HISTORIC AND DESIGN REVIEW COMMISSION

May 01, 2019

HDRC CASE NO: 2019-206
COMMON NAME: 7519 Old Corpus Christi Rd
LEGAL DESCRIPTION: NCB 10930 BLK LOT SW IRRG 209.7 OF TR 4
ZONING: C-3, RIO-6
CITY COUNCIL DIST.: 3
APPLICANT: Patrick Spencer
OWNER: Hugh Horne/HPI Horne Storage
TYPE OF WORK: New Construction
APPLICATION RECEIVED: April 11, 2019
60-DAY REVIEW: June 12, 2019
CASE MANAGER: Edward Hall

The applicant is requesting a Certificate of Appropriateness for approval to construct a three story, self-storage facility at 7519 Old Corpus Christi Road. The proposed self-storage facility will feature frontage on both Old Corpus Christi Road and SE Military Drive.

OVERALL SITE PLAN

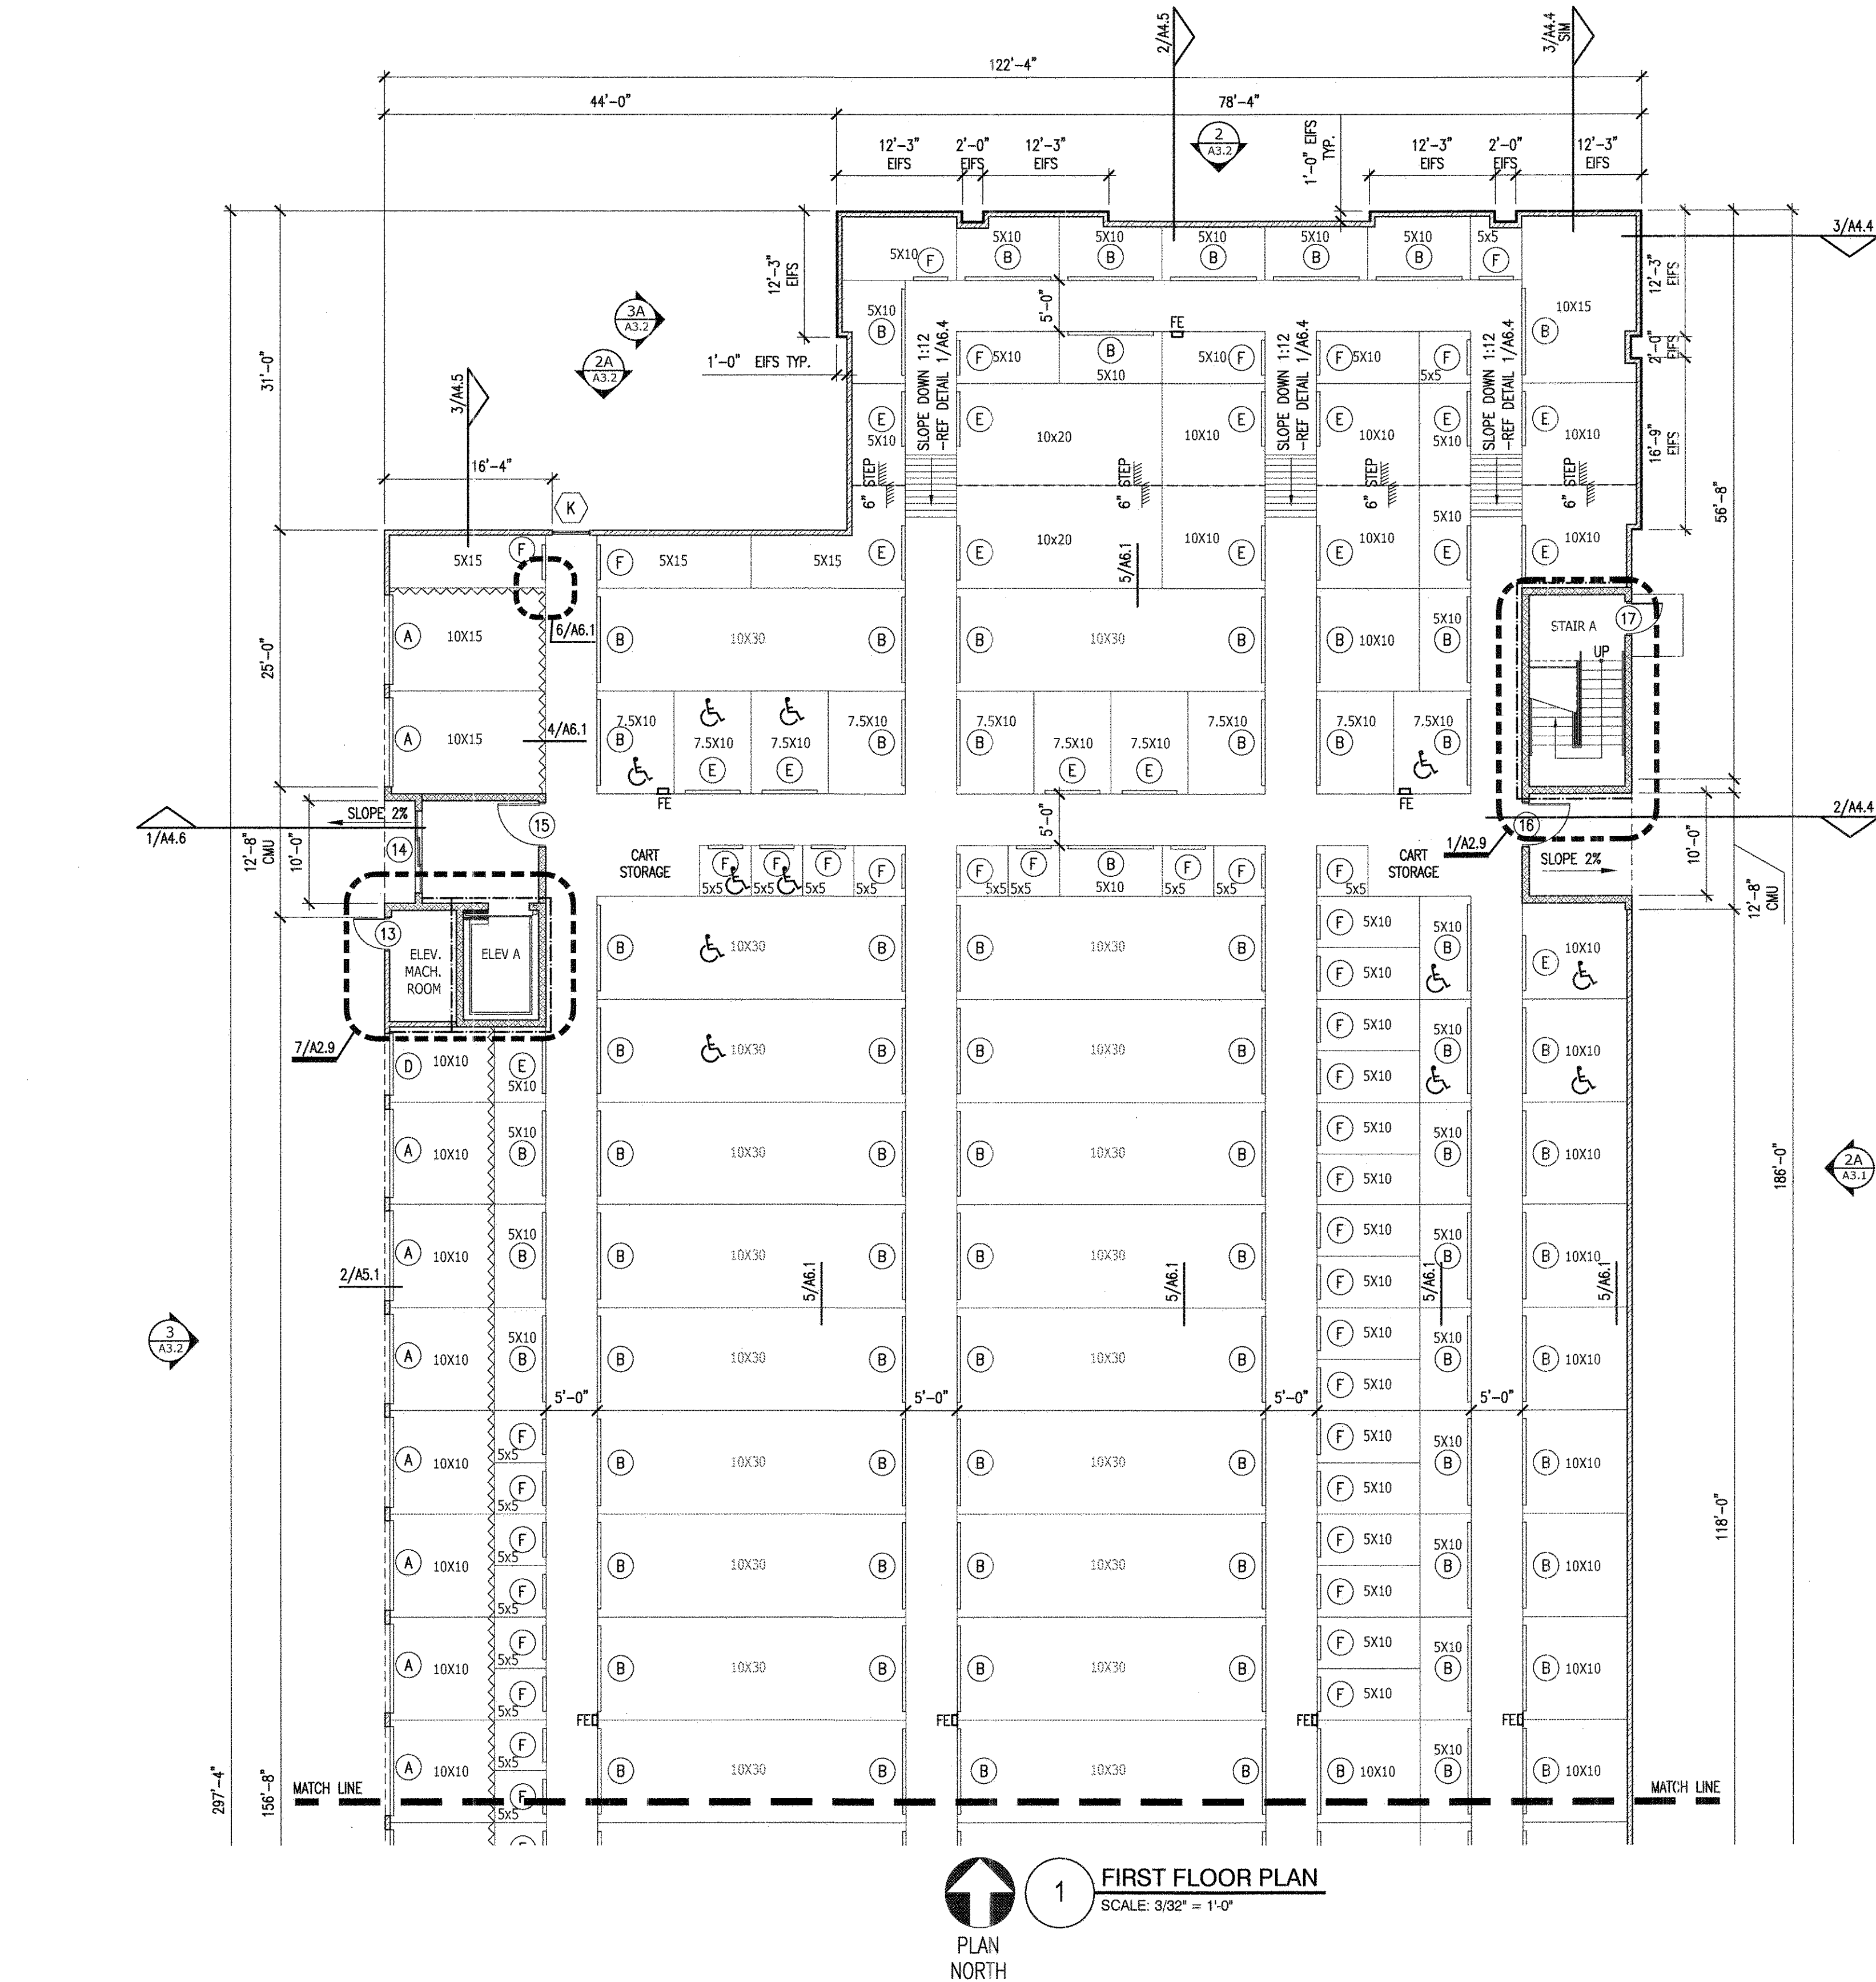
- b. PEDESTRIAN CIRCULATION – Per the UDC Section 35-672(a) in regards to pedestrian circulation, an applicant shall provide pedestrian access among properties to integrate neighborhoods. Per the applicant’s site plan, a sidewalk will be installed at the right of way parallel to Old Corpus Christi Road to run the length of the property. This is consistent with the UDC.

- f. LANDSCAPE DESIGN – The applicant has provided landscaping information on the site plan and has submitted a landscaping plan in the construction document set. Staff finds the proposed landscaping plan to be appropriate.
